SUBJECT: 25-040 Loaf Land Subdivision - Comment Response

Thank you for your continued review of the Subdivision Application Permit (SP 4103) for Loaf Land Subdivision in Coplin Plt.. The team recently received the additional review comments from LUPC in regard to this application, dated August 27, 2026. These comments can be seen below in *italic*, followed by Main-Land's response in regular typeset. Updated or amended exhibits have been provided as attachments.

A1

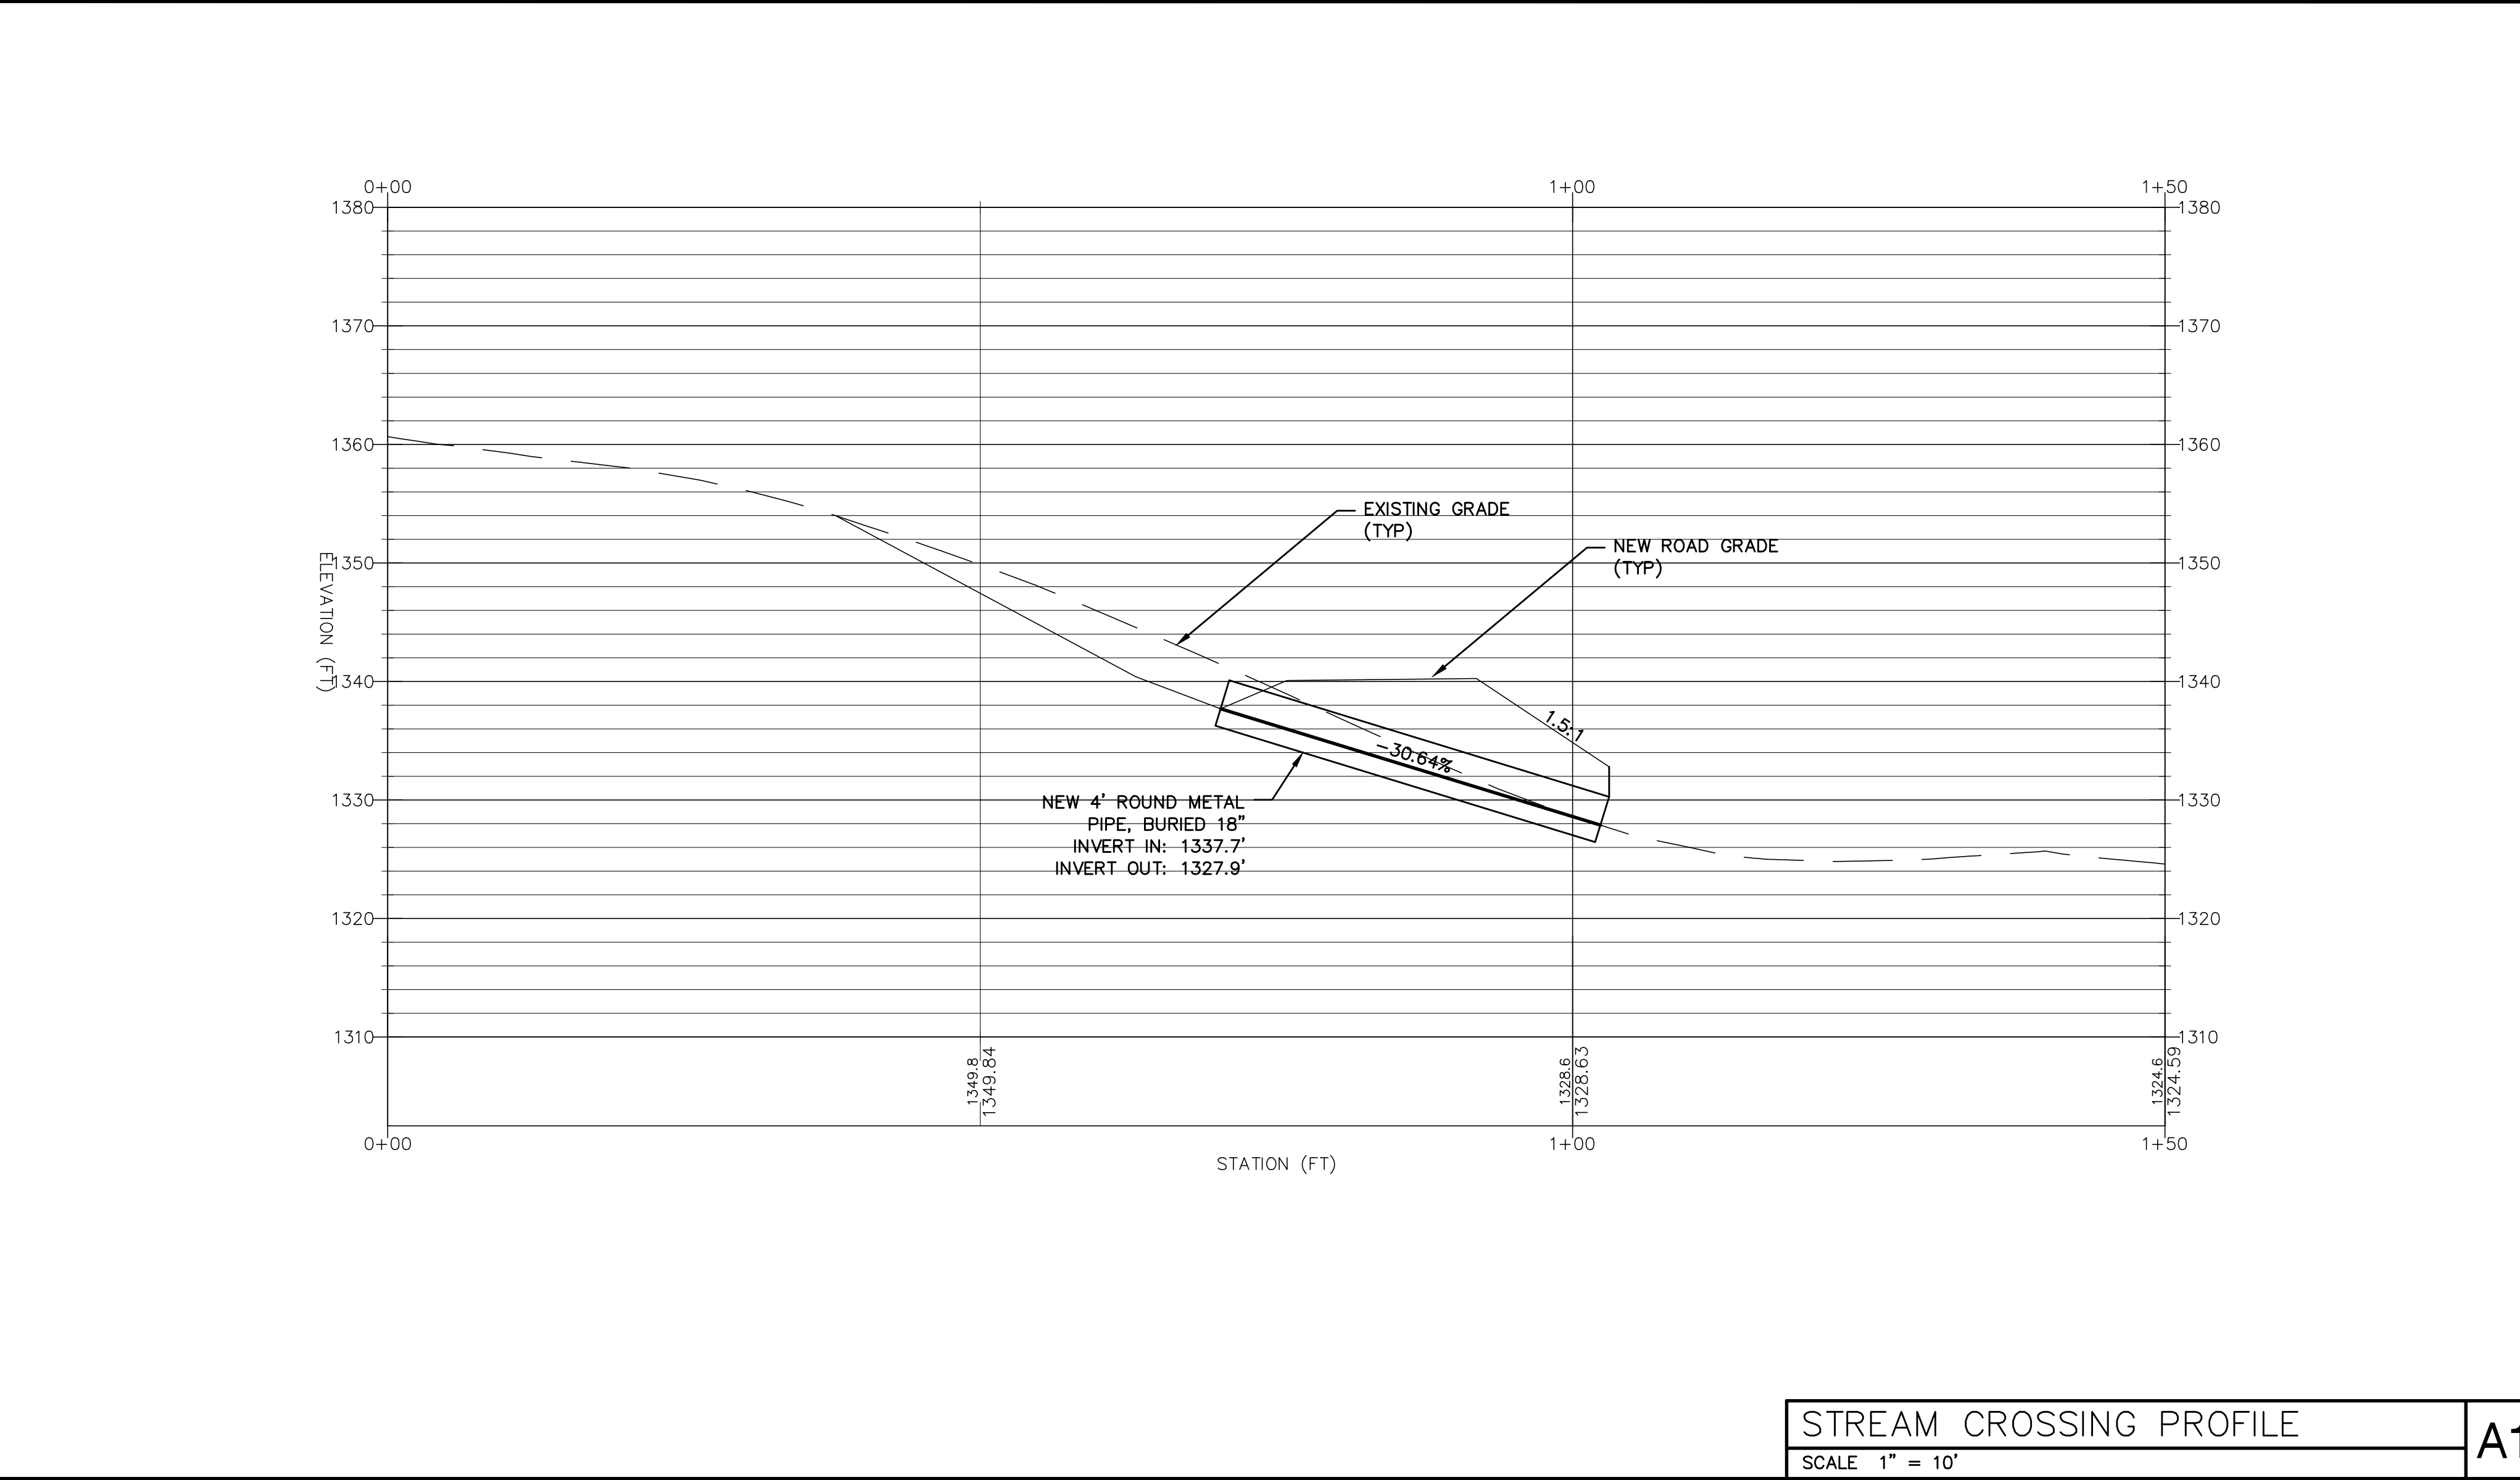
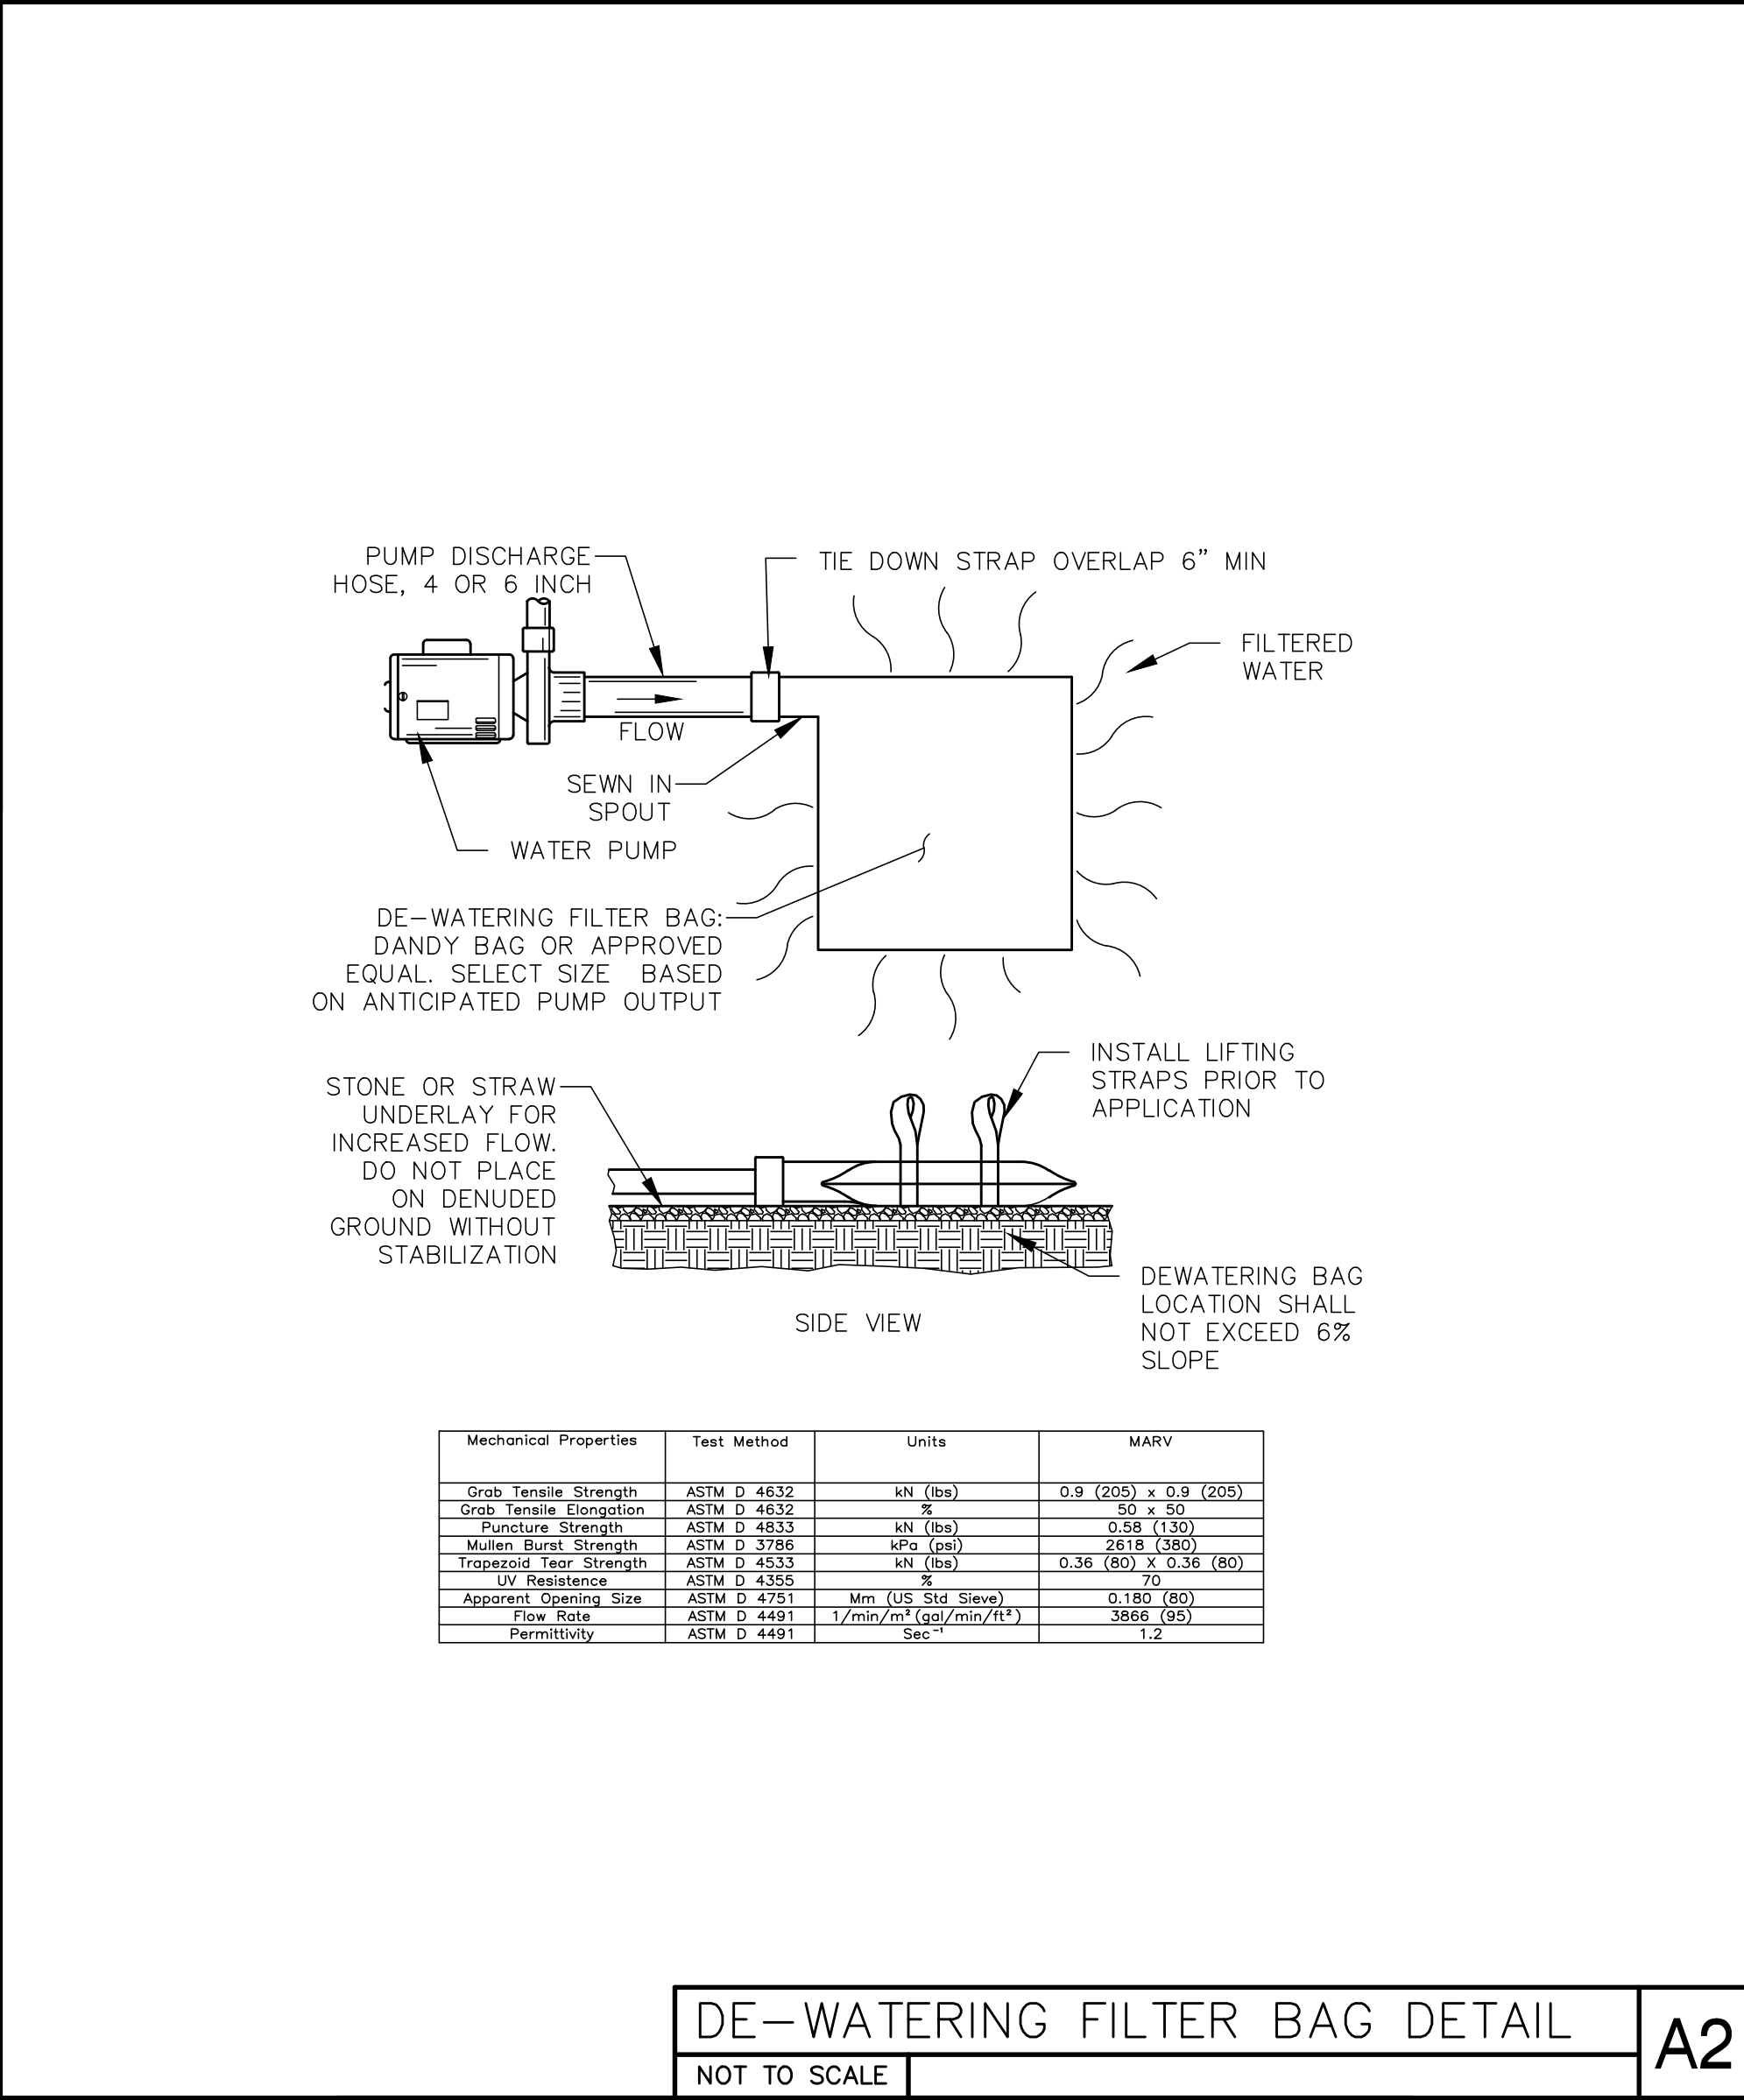
- *On Plan C5.1 (Road Plan and Profile), consider moving the proposed underground electrical conduit to either side of the ditch (see Sebago Technics review comment IV.12 on Sheet C5.1).*
 - *Sebago Response: The proposed electrical conduit is shown running down the centerline of the roadside ditch for Mountain Village Road. The designer should consider moving the conduit to either side of the ditch to avoid shallow cover and water intrusion.*
